**Re: Phelps Dodge Tyrone, Inc. – DP-1341, Condition 89,**  
**Tyrone Mine Feasibility Study Work Plan, Response to NMED Comments**

**Feasibility Study Work Plan  
Tyrone Mine Facility**

**Prepared for  
Phelps Dodge Tyrone Inc.  
Tyrone, NM**

**Figure 1 Location of Open Pits and Stockpiles at the Tyrone Mine**

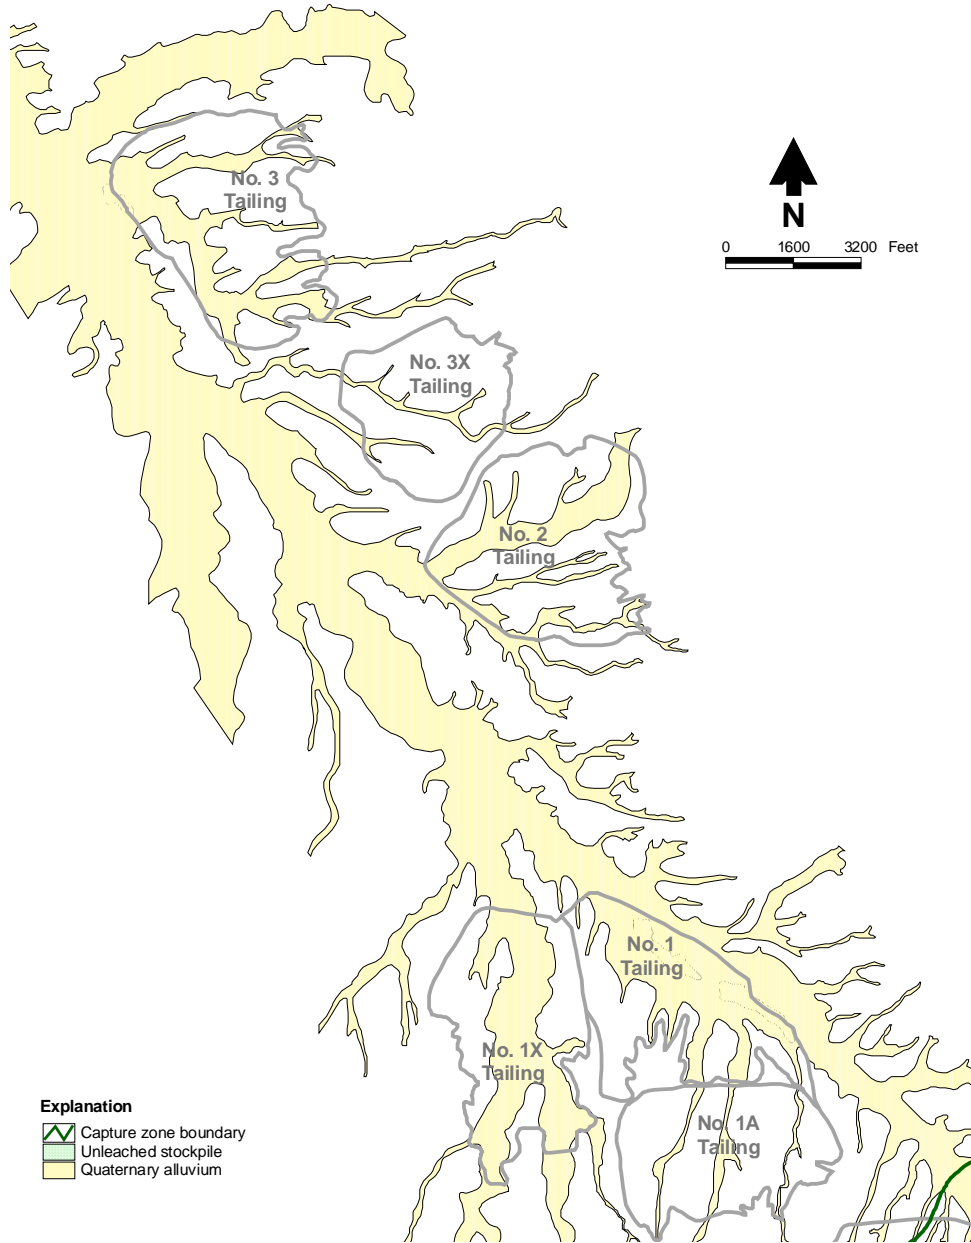
- Site maps Figures 1 and 2 identifying mine facility locations have been included.
- A bibliography of references is included as Section 6 of the Work Plan.
